To: All bidders of Town of Delhi Municipal Swimming Pool Project

Re: Addendum No. 1 to Construction Contract Documents

PROJECT:  
 TOWN OF DELHI, NEW YORK  
 MUNICIPAL SWIMMING POOL & BATH HOUSE PROJECT

DRAWING TITLE:  
 SITE PLAN OF POOL AREA & DRY WELL DETAIL

SITE PLAN OF POOL AREA  
 SCALE 1" = 10'

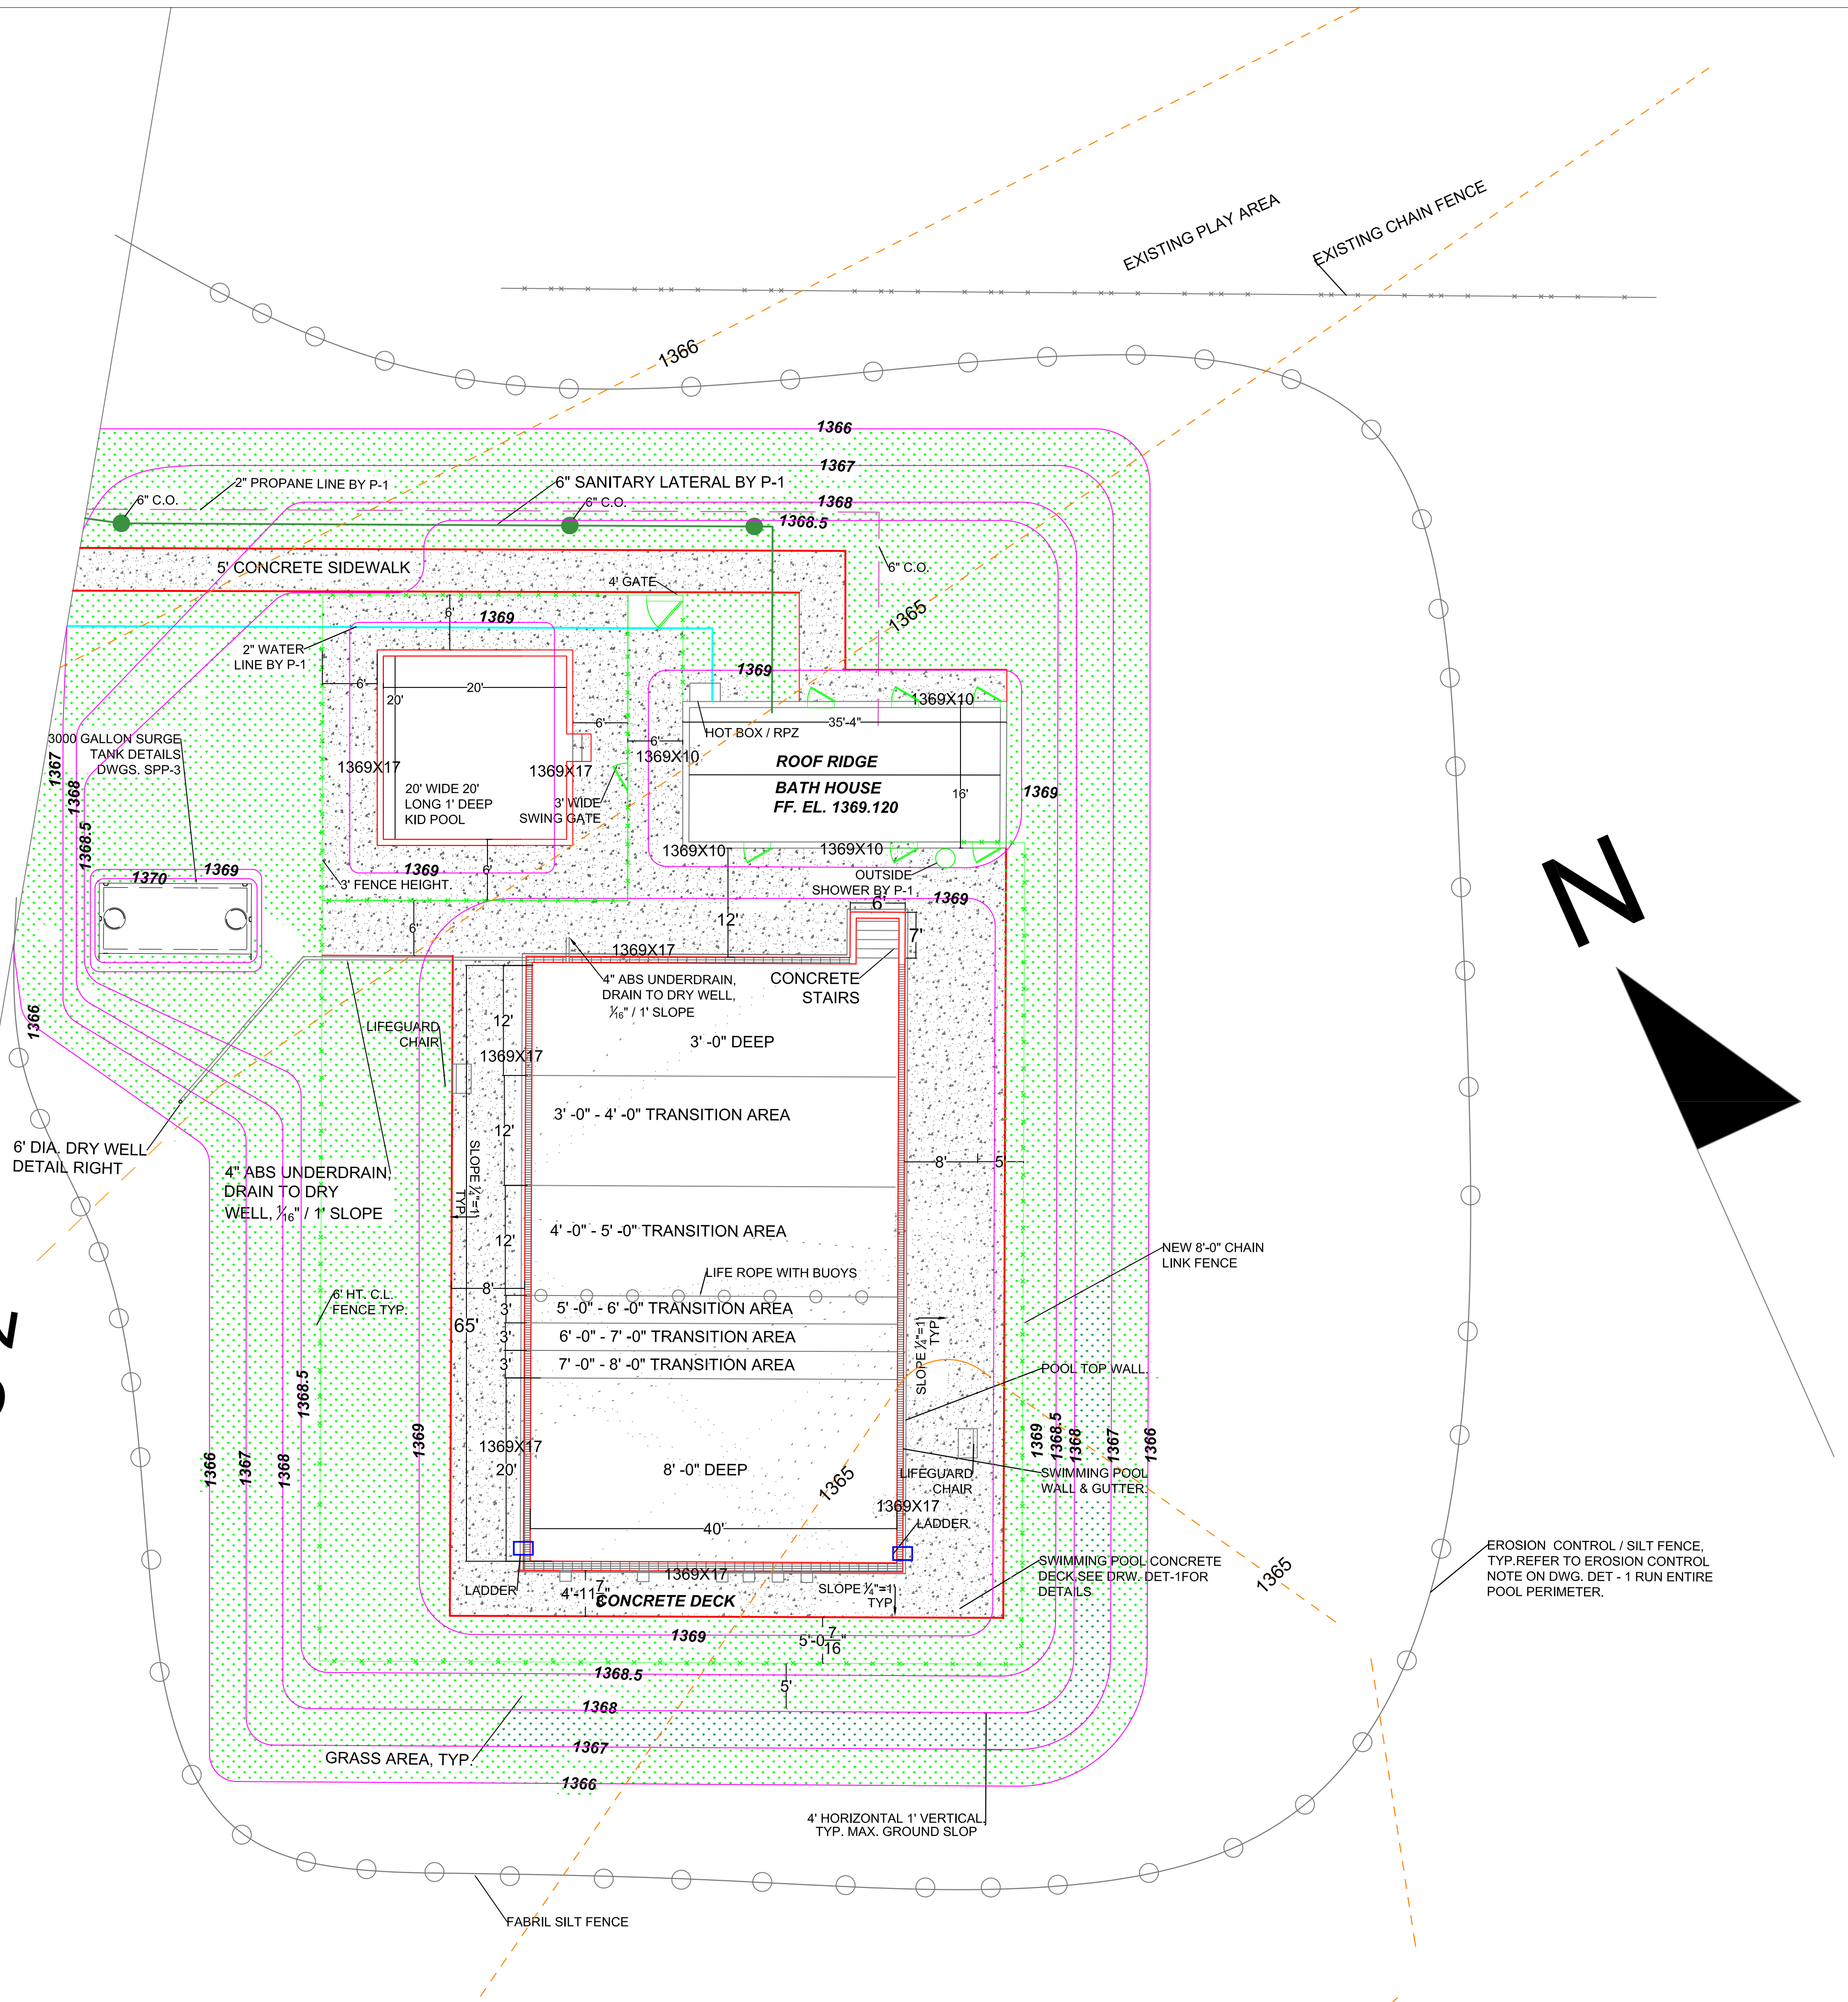
Please find attached Drawing S-1 which replaces the original bid set drawing. This drawing includes existing contour lines which were missing on the original drawing.
